Memorandum to the City of Markham Committee of Adjustment

File: A/106/23
Address: 86 John Street (Thornhill)
Applicant: Scott Rushlow Associates Ltd.
Hearing Date: Wednesday, October 9, 2024

The applicant is requesting relief from the following requirements of By-law 2237, as amended, as it relates to a proposed rear addition:

Proposed Site Plan 1.11c

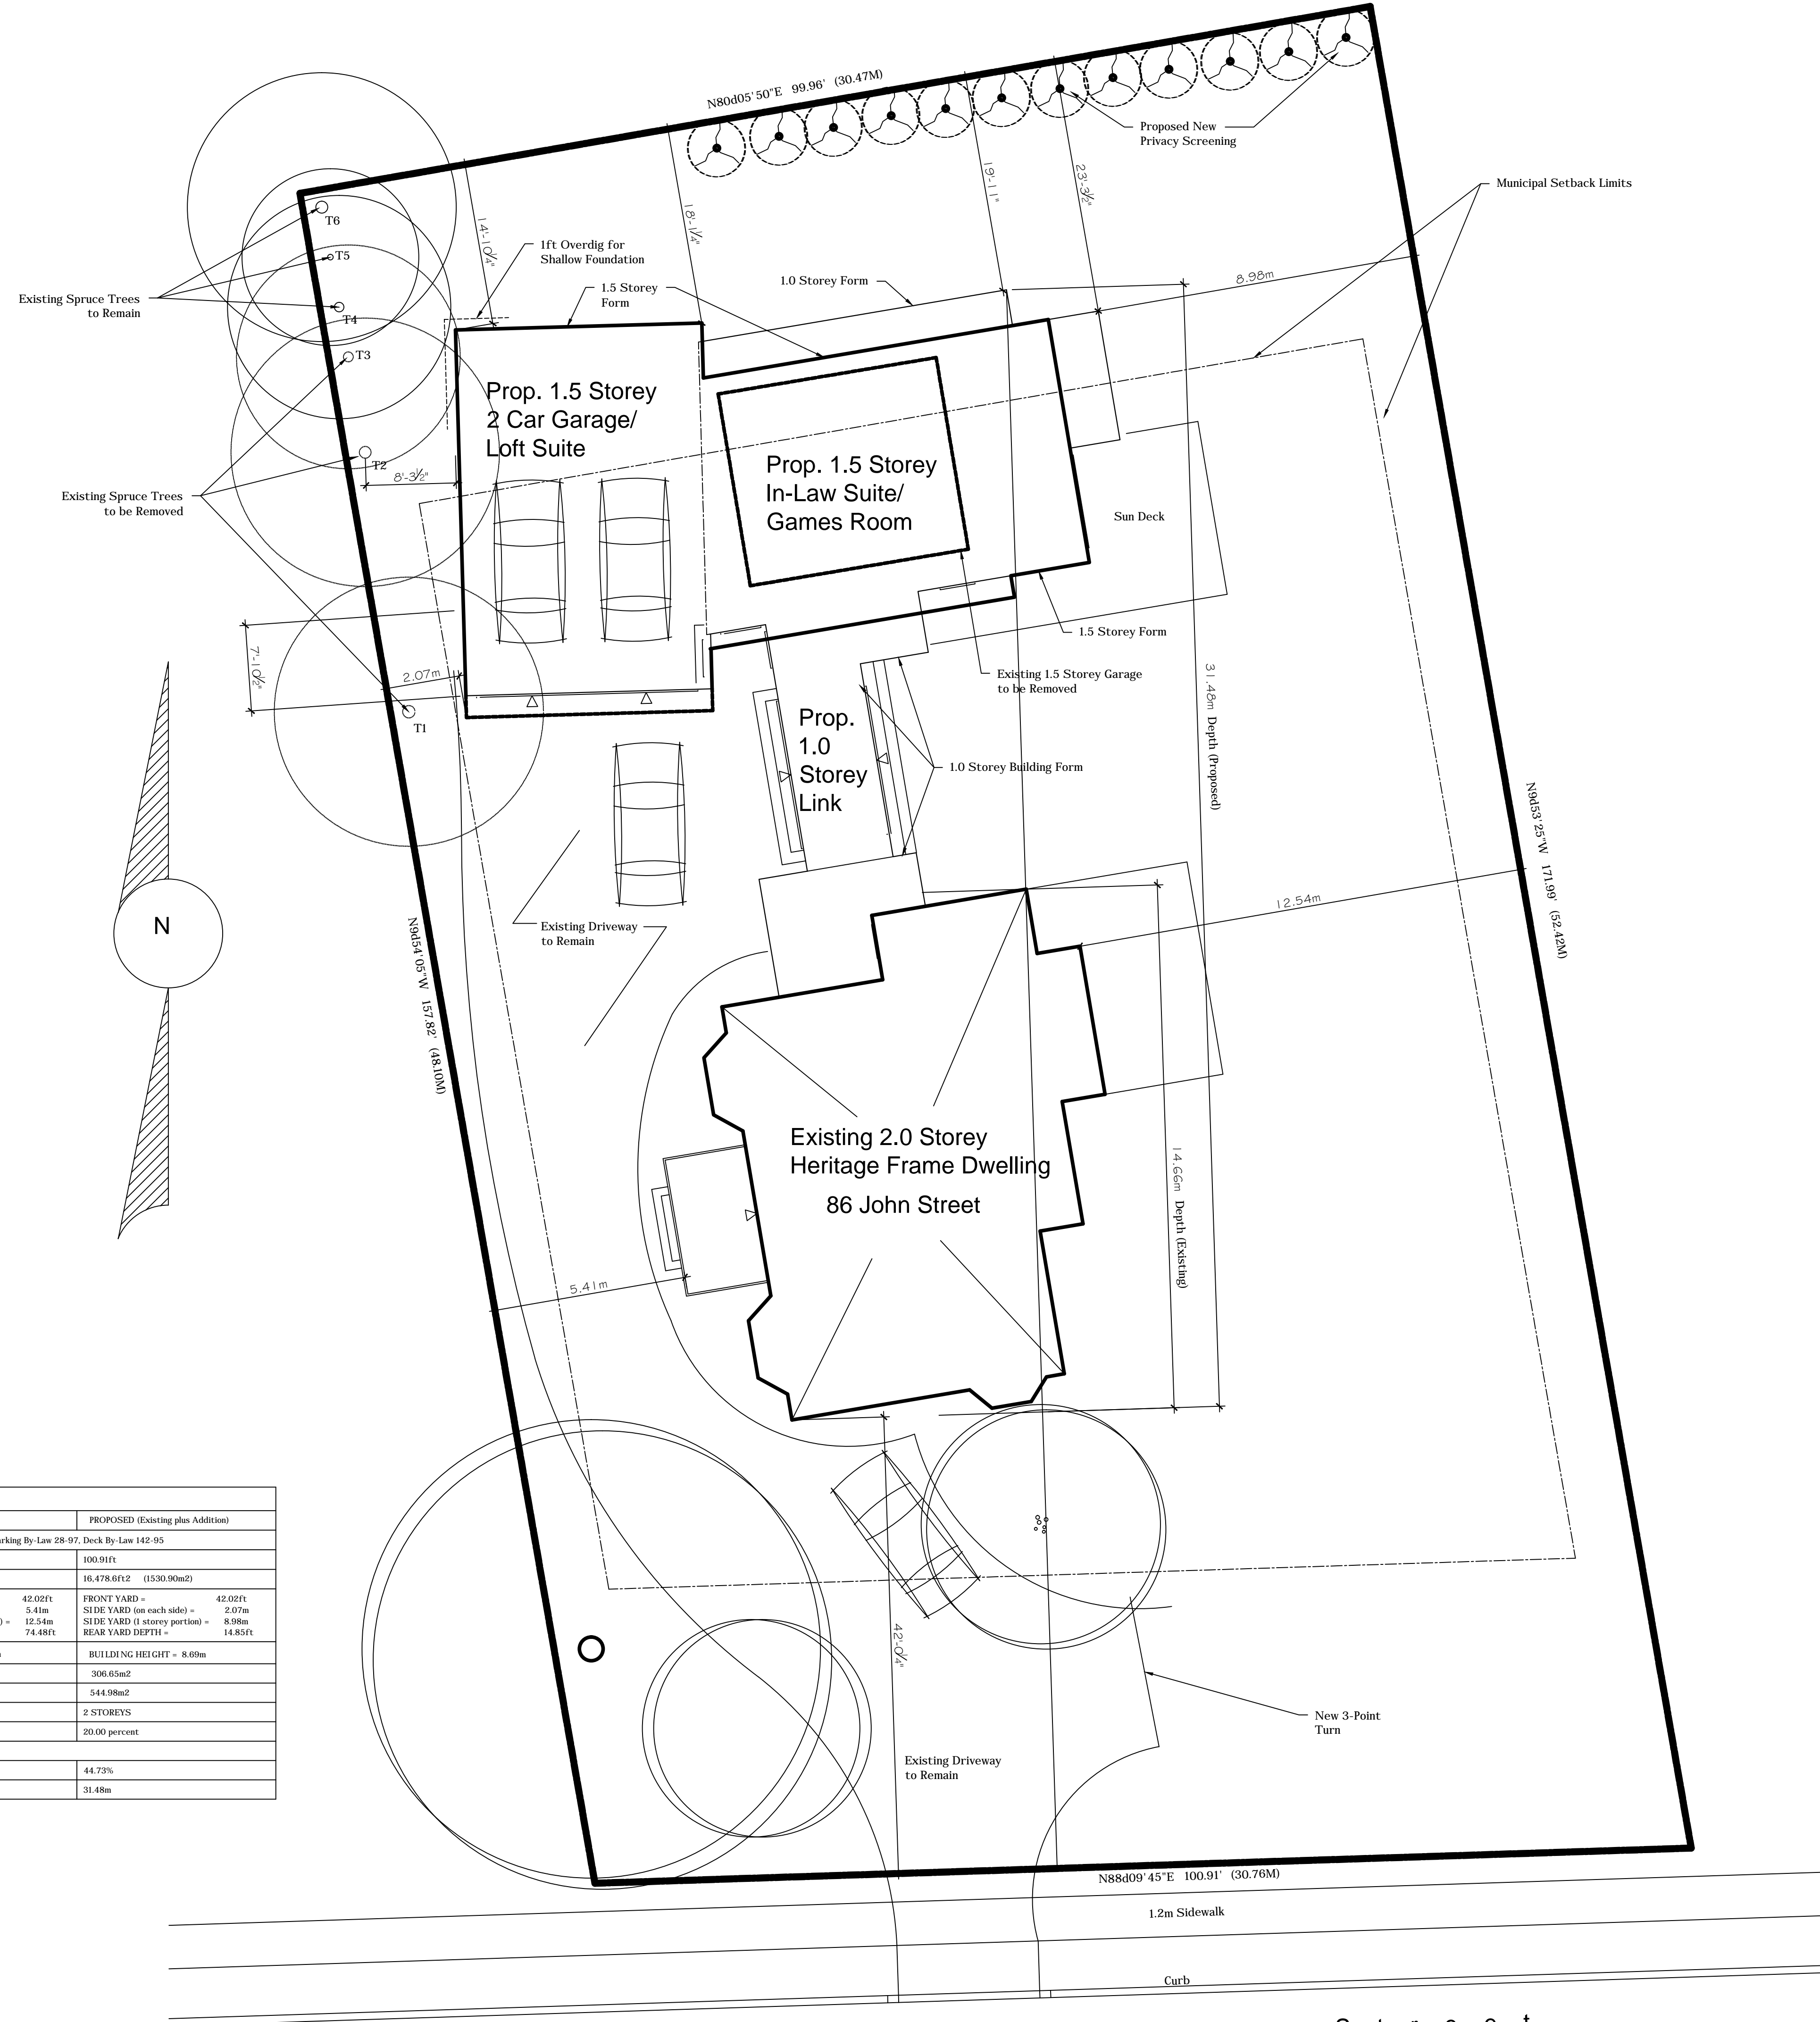
The applicant is requesting relief to permit a maximum building depth of 31.48 m (103.28 ft), whereas the By-law permits a maximum building depth of 16.8 m (55.12 ft). This represents an increase of approximately 14.68 m (48.16ft). Building depth is measured based on the shortest distance between two lines, both parallel to the front lot line, one passing through the point on the dwelling which is the nearest and the other through the point on the dwelling which is the farthest from the front lot line. The applicant is also requesting relief to permit a minimum rear yard setback of 14.85 ft (4.53 m), whereas the By-law requires a minimum front yard setback of 30 ft (9.1 m). This represents a reduction of approximately 15.15 ft (4.62 m).

Staff note that the extent of the variance for building depth is required because the proposed addition is attached to the existing dwelling by a link and therefore the entire building mass is considered the main house from a zoning perspective. As the existing dwelling and addition will be perceived as

Staff also note that the addition has been programmed to reduce overlook and privacy concerns for adjacent property owners, notably 4 Leahill Drive. Those spaces most frequently used and/or those that require larger windows have been placed along the south and east elevations of the addition where they are the farthest from adjacent dwellings. This includes the dwellings immediately to the east and west of the Subject Property at 90 and 84 John Street, respectively.

Lot configuration further mitigates the visual impact of the proposal despite its proximity to 4 Leahill Drive. The addition is sited adjacent to the side yard of this property where it is outside the primary site line of those enjoying amenity space within its rear yard. Mature plantings along the side yard of 4 Leahill Drive will further diminish visibility of the proposed addition. As such, it is the opinion of Staff that the variances for building depth and rear yard setback do not significantly alter the contextual relationship between the two properties.

From a heritage perspective, the proposed rear yard setback is supportable as it ensures that the addition does not visually compete with the diminutive character of the existing dwelling on the Property as seen from John Street. As the primary elevation of the heritage building fronts John Street, it is from this vantage point that Staff assess impact on both the heritage integrity of the Subject Property and the THCD more broadly. Were the addition to be sited closer to the existing dwelling, Staff are of the opinion that it would have an adverse visual impact on the Class 'A'-rated heritage resource owing to its height, thereby running counter to policy direction and guidance in the THCD Plan. Staff are also of the opinion that the siting and scale of the proposal has minimal visual impact on the heritage character of 4 Leahill Drive given the distance of the addition from Leahill Drive. As the primary elevation of this heritage building fronts Leahill Drive, it is from this vantage point that Staff assess the proposal's impact on heritage integrity.

6. That vegetative screening be planted adjacent to the north elevation of the addition to the satisfaction of the Director of Planning and Urban Design, or their designate, through the Major Heritage Permit Approval process.

7. That a 6ft privacy fence be erected along the rear property line to the satisfaction of the Director of Planning and Urban Design, or their designate, through the Major Heritage Permit Approval process.
